# **Proposed Decision to be taken by the Portfolio Holder for Transport and Environment on or after 18 August 2017**

## **Objections to Proposed Traffic Signals at D7050 Common Lane, Kenilworth**

Detailed layout plan

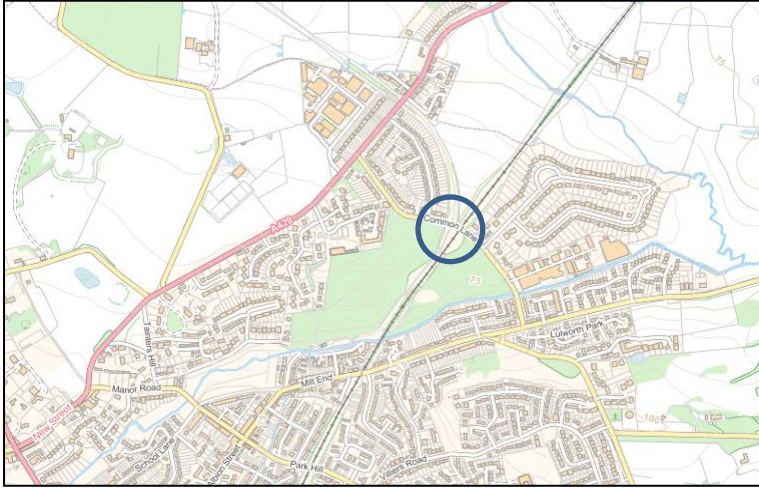
**Point 3:** There does not appear to be adequate provision for cyclists and pedestrians.

For cyclists, it was not explicitly shown on the consultation plan that the traffic signals include specific microwave technology detectors which point into the junction which will also extend the "all red time" when cyclists are travelling through the junction. The traffic signal controller will work out the amount of time needed for the cycles and vehicles to clear the junction before changing to a green light. A more detailed plan can be seen in **Appendix A**.
